DCP/NRC1232  
NSD-NRC-98-5543  
Docket No.: 52-003

SUBJECT: AP600 RESPONSE TO FSER OPEN ITEMS

Enclosure to Westinghouse  
Letter DCP/NRC1232

Figure 3 - Zone 11300 A / B Ceiling Vents

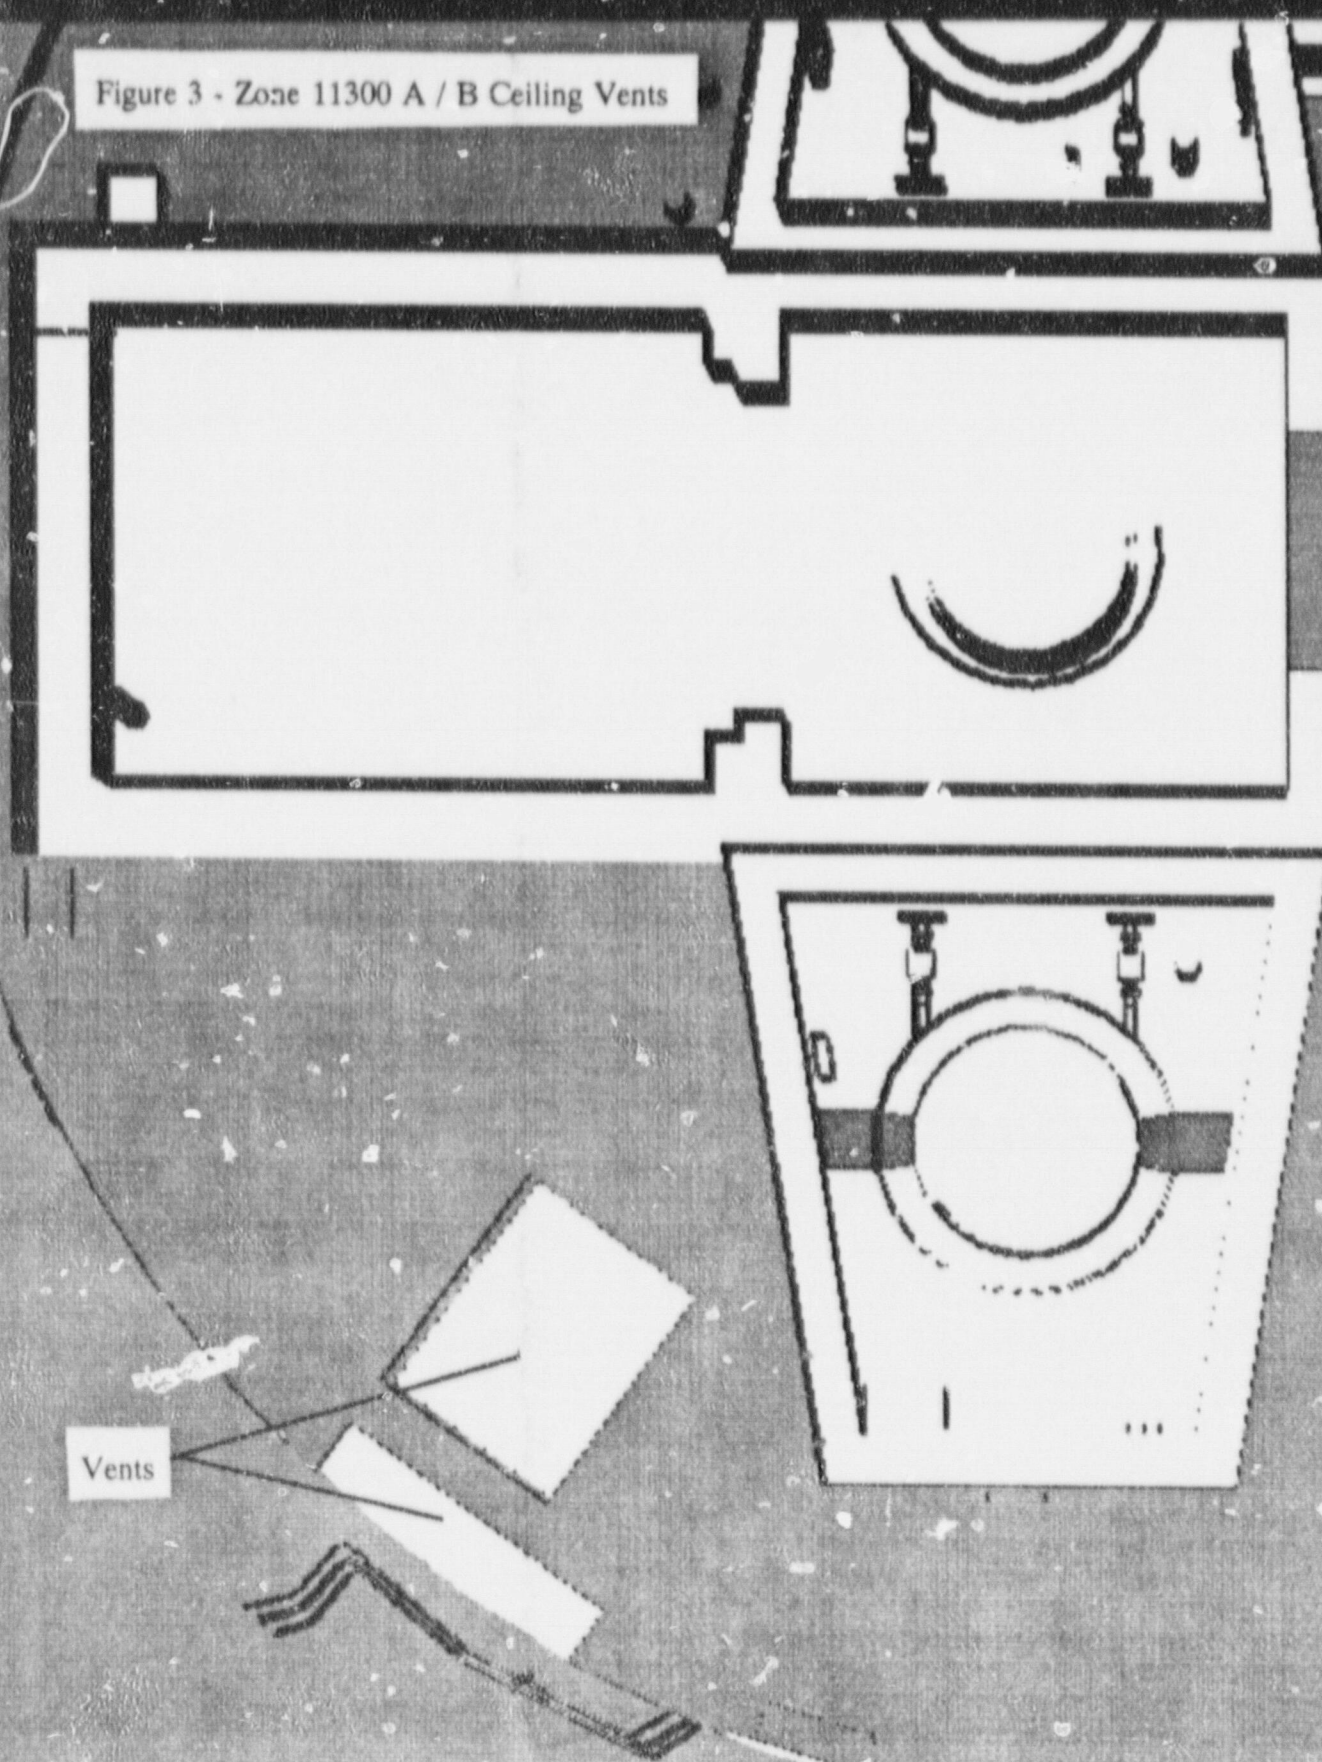
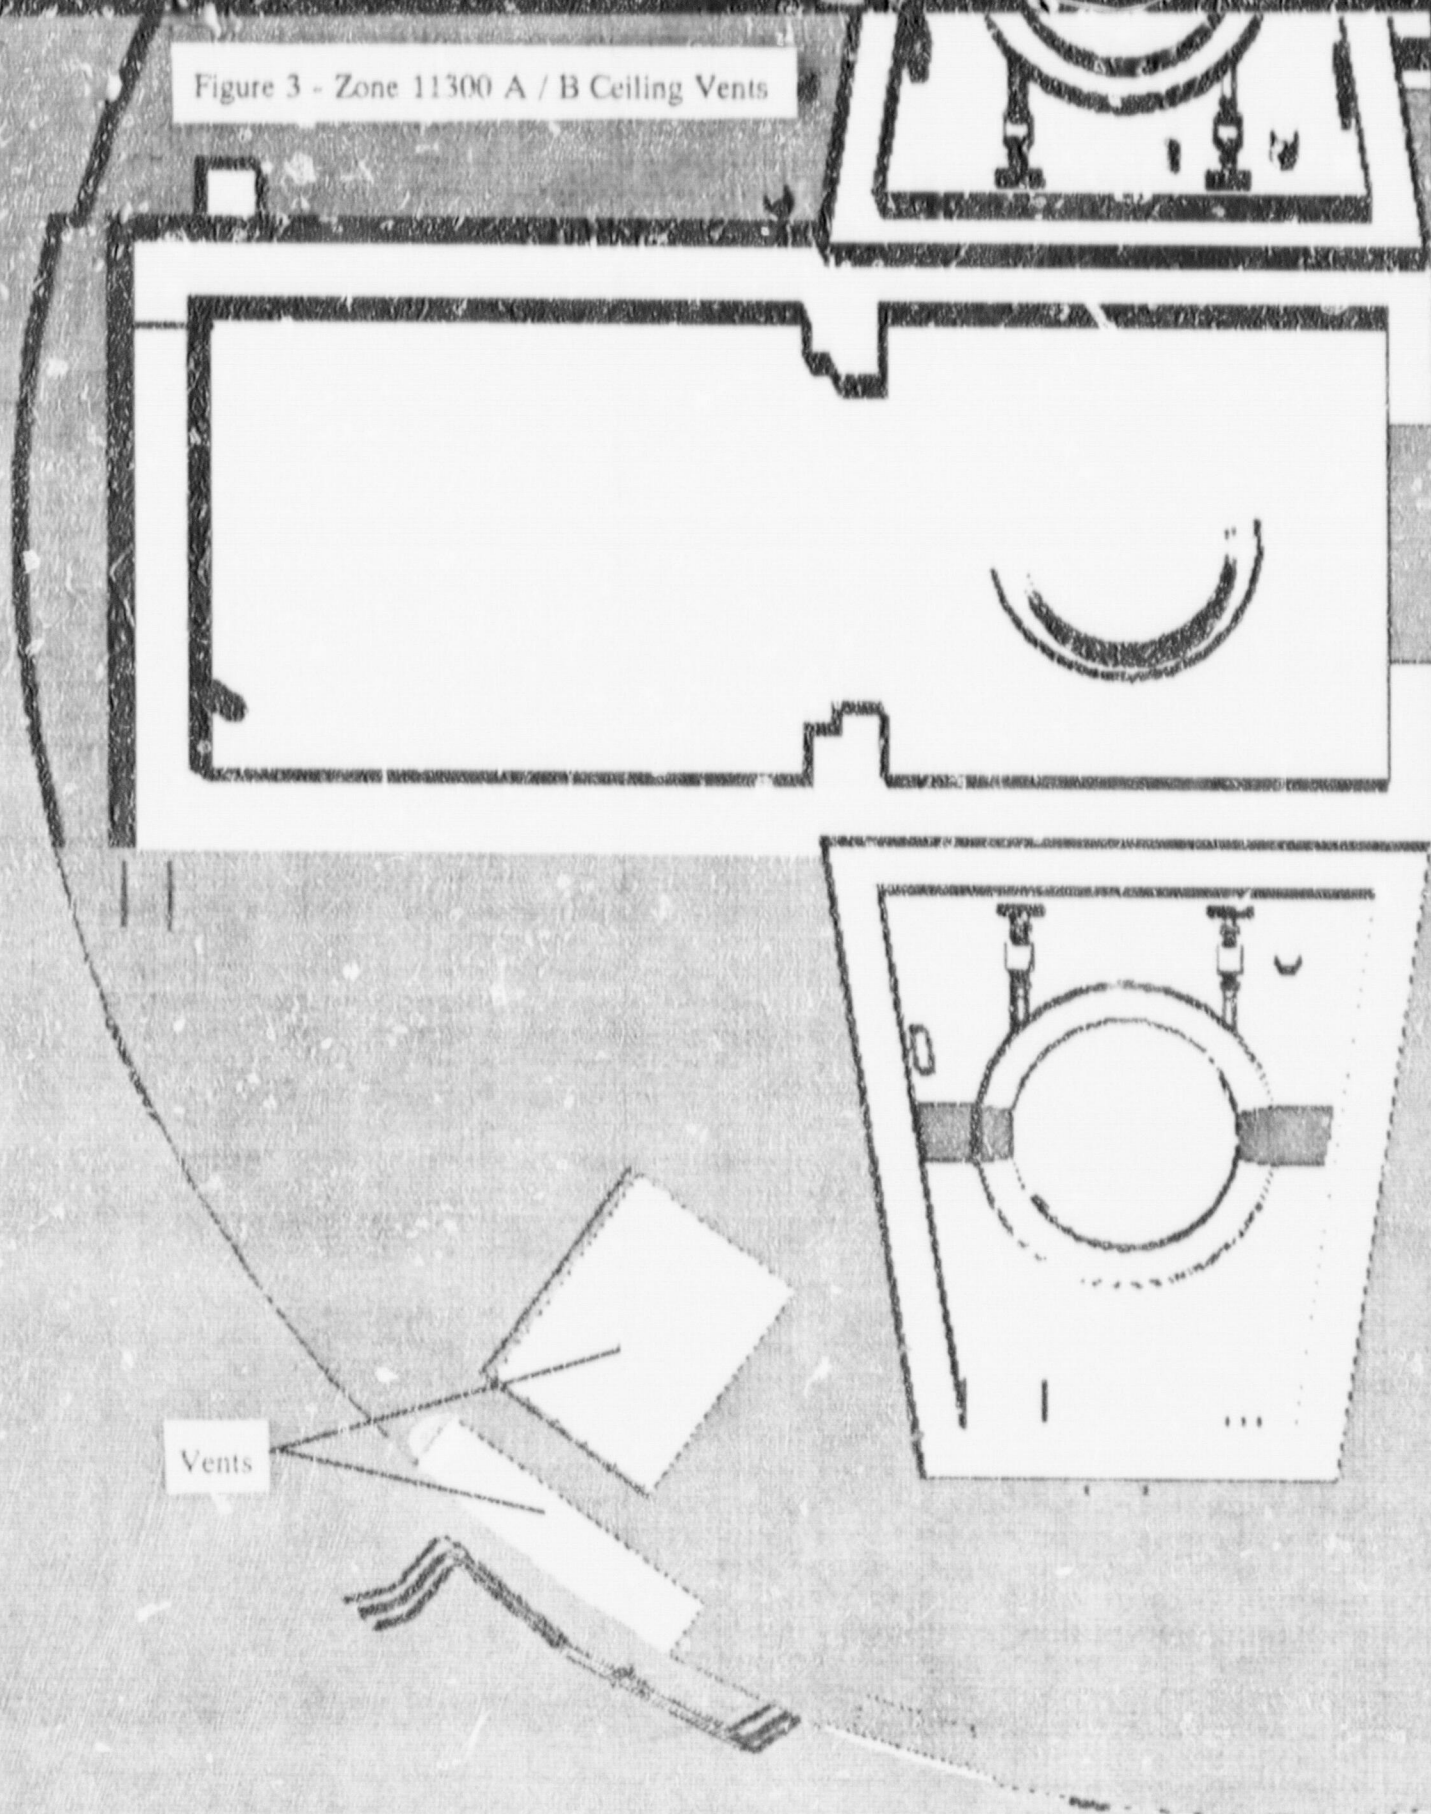
Figure 3 shows the large vents through the roof of zones 11300A/B. Figure 4 shows cable trays in the 11300B fire zone. Note that the safety-related cable trays are enclosed types. The nonsafety-related cable trays are open types. The division B/D cable trays in zone 11399S will be enclosed by noncombustible barriers made of steel or steel composite materials. The limited amount of combustibles located in this zone together with its high ceiling and large volume indicate that it would not heat up rapidly. Hot gases from a fire in the cable tray area will rise away from the cable trays and exit to the upper containment volume above operating deck. These hot gasses are impeded from crossing over from zone 11300B to 11300A by the large I-beams that support the concrete operating deck (see Figure 4). Some of these I-beams are about 3 feet deep. If some hot

gas is not vented to the upper containment volume and works its way past the I-beams under the operating deck, it would be vented up to the upper containment volume through the large vents in the operating deck in zone 11300A (see Figure 3). Note that safety-related equipment is not located near the ceiling of these two fire zones. Also note that safety-related equipment located inside containment is qualified for elevated temperatures of 340 F. As a result, safety-related equipment located in 11300A or 11300B would not see elevated temperatures from a fire in the other zone that would exceed their environmental conditions.
